FORESTSIDE TOWNHOUSES

SITE INSTRUCTION # 4

Date: May 21st, 2021

JAP Project No: 19066

Date Plotted: May 20 2021
Drawn By: ND
Checked By: JW
Job No.: 19066
Scale: 1 : 100
Revision Number:
Sheet No.: S-103B

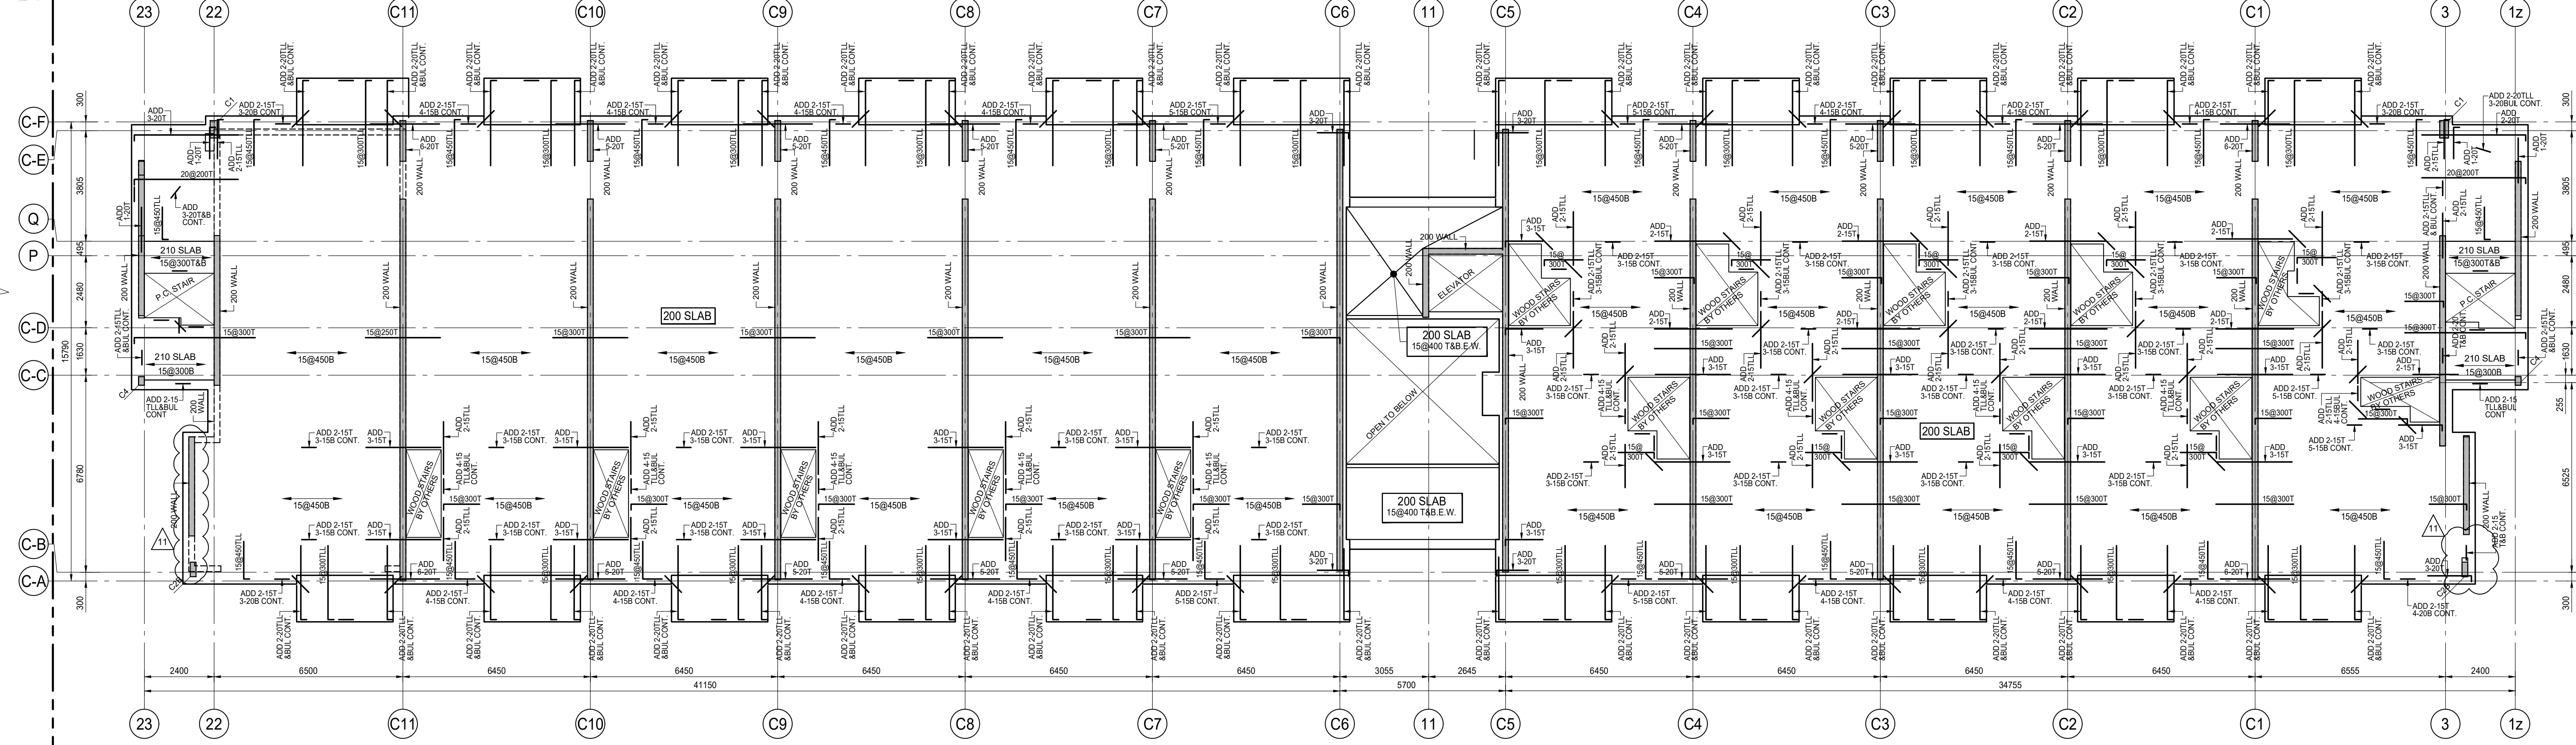
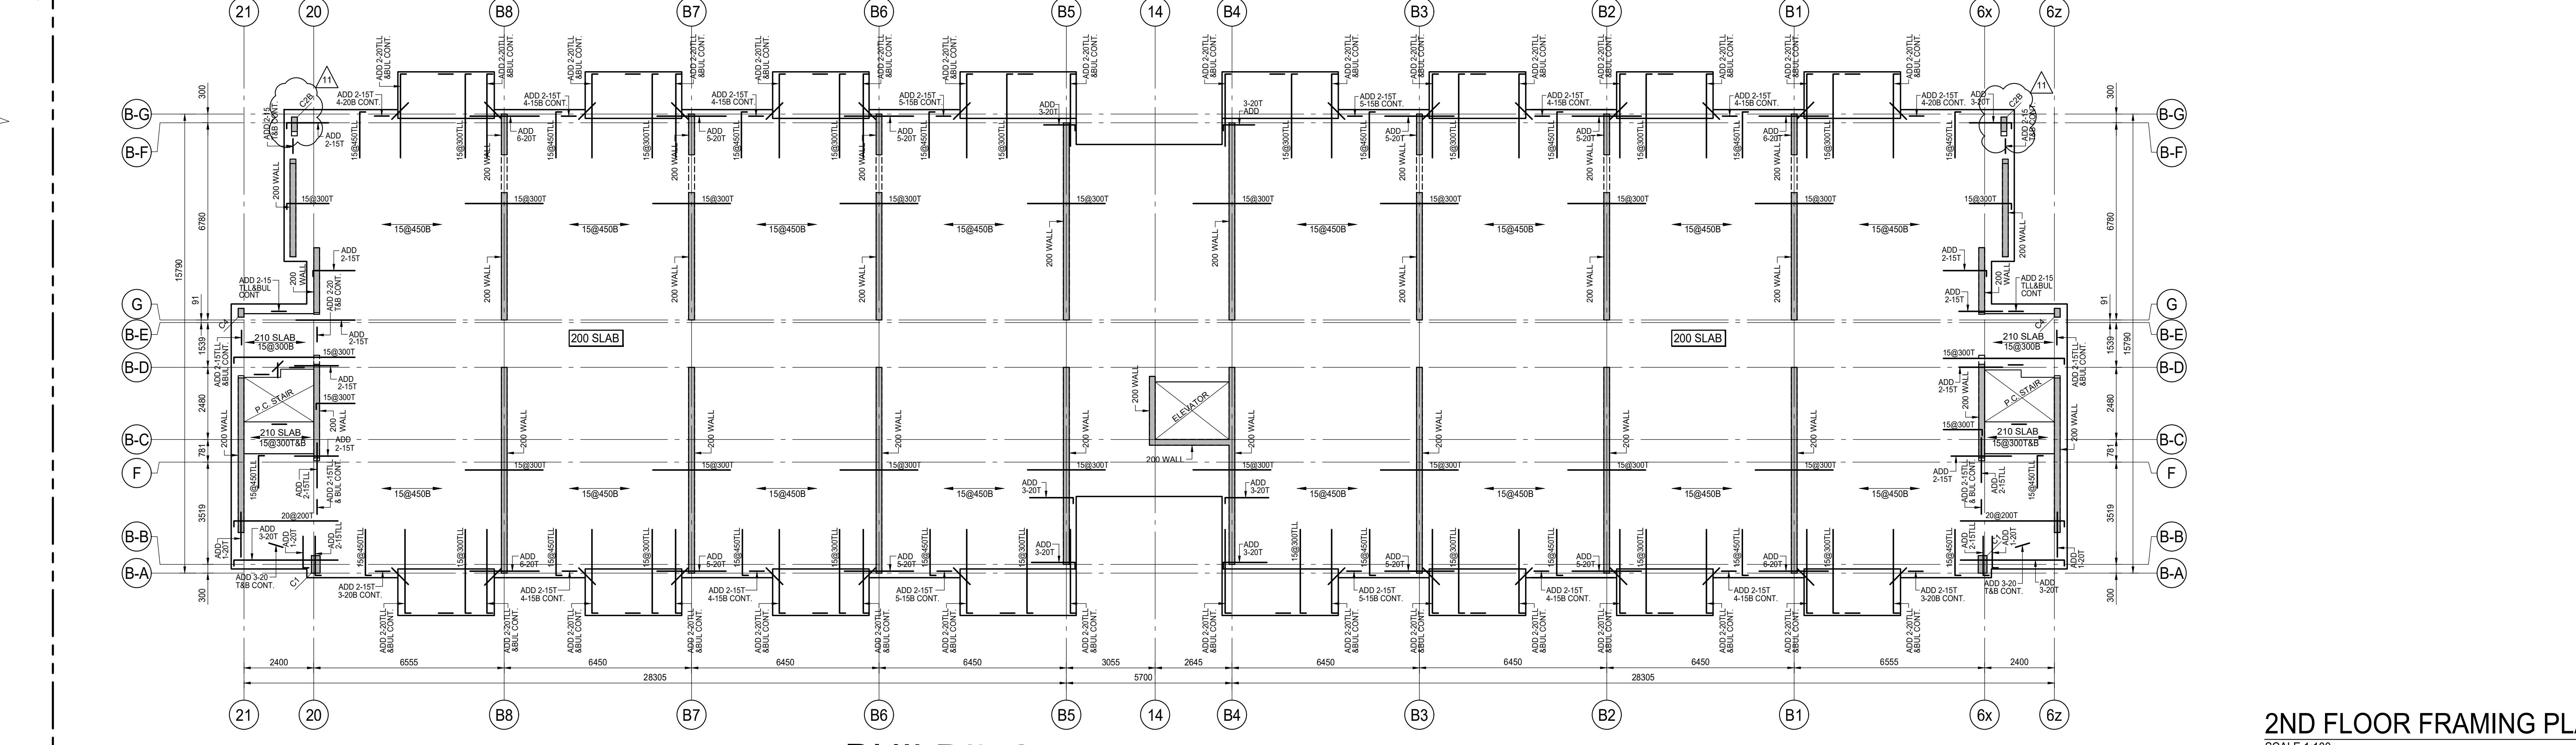
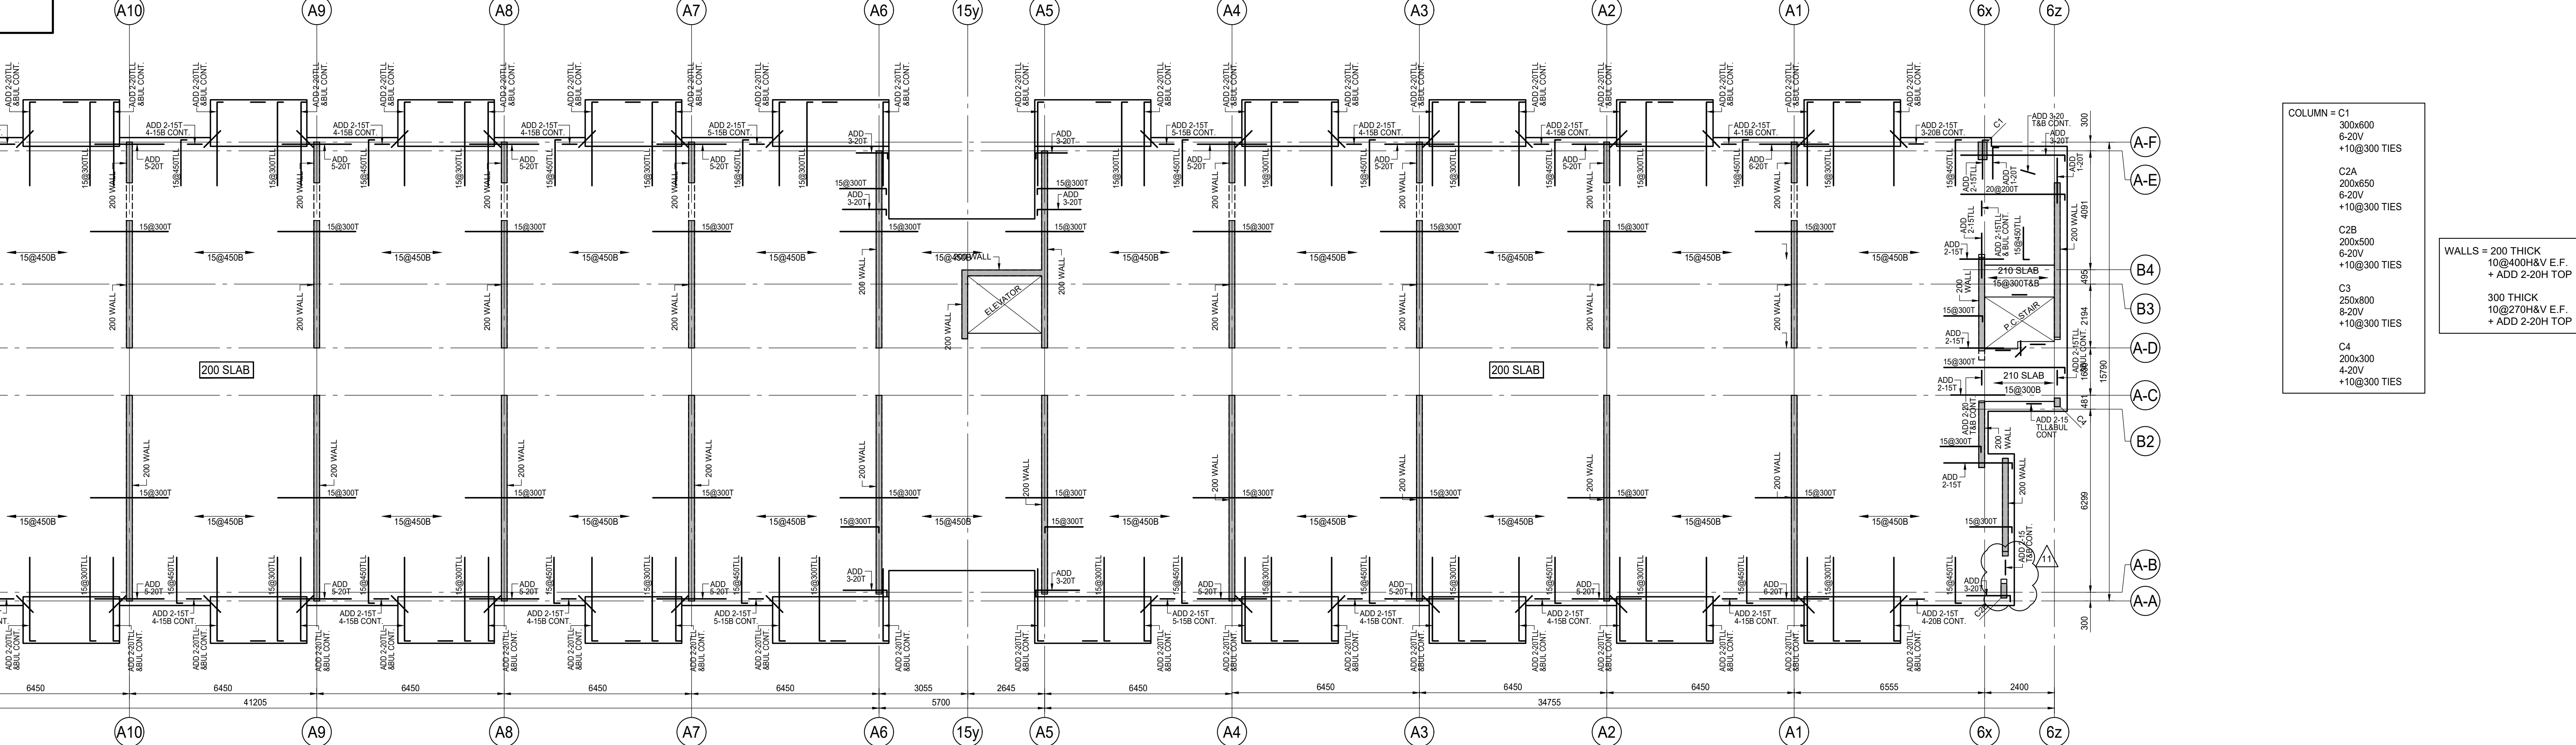
1.3 **Refer to Drawing S-103A & B "2ND FLOOR FRAMING PLAN"**

- j) Matched latest column location from arch
- k) Updated openings for corridor on Building D
- l) Filled in slab at elevator area on Building D
